March 20, 2017

Re: Revised Fan Fare Redevelopment (#1158458) / Pre-Application Meeting held October 6, 2016  
Comment Response Letter

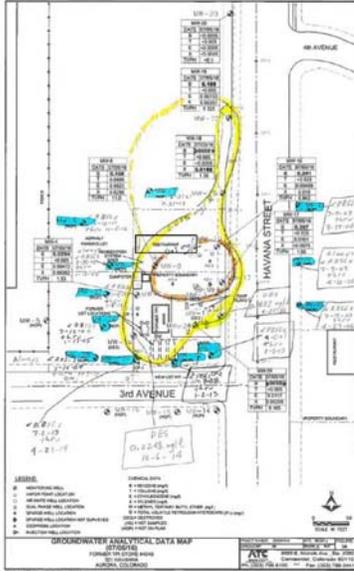
2C. *Bus Stop Shelter.* Staff has identified the need for a bus stop shelter at the intersection of Havana and 4<sup>th</sup> Avenue. Please coordinate with RTD's Planning Project Manager, Lacy Bell, to identify the appropriate structure, or create a design unique to your site, and provide that detail on your next submittal. She may be contacted at [lacy.bell@rtd-denver.com](mailto:lacy.bell@rtd-denver.com).

Response: This item will be addressed in Phase II
